RE: DRAINAGE PLAN FOR DAWSON APARTMENTS

(K-19/D84) ENGINEERS STAMP DATED MAY 12, 1987

GRADING AND DRAINAGE PLAN DAWSON APARTMENTS

GRADING AND DRAINAGE PLAN SCALE | | = 10'

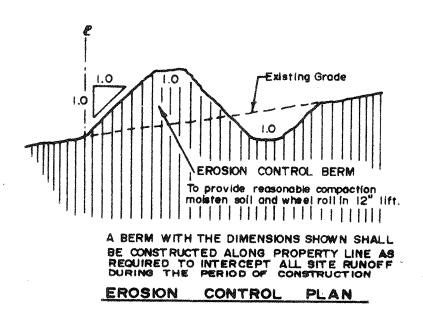
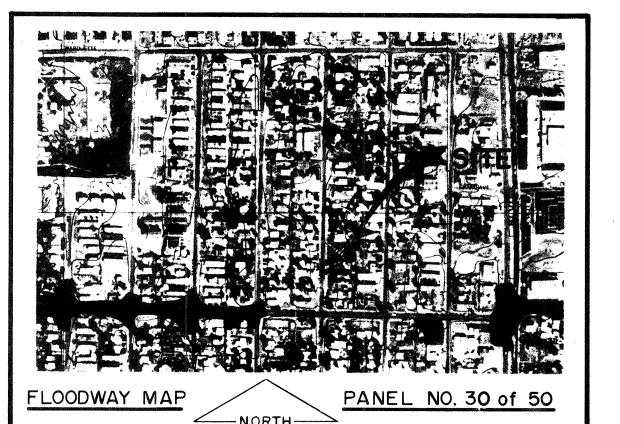
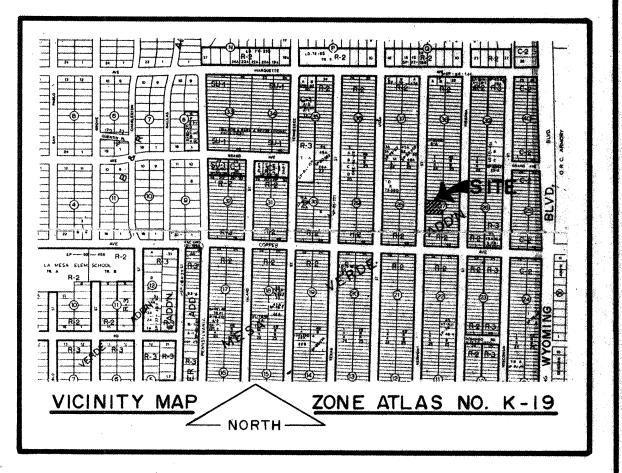
Based on the information provided on your submittal of May 13, 1987, the above referenced plan is approved for Building Permit.

Please be advised that the Building Permit will not be issued until an approved copy of the replat is received by our office for our files.
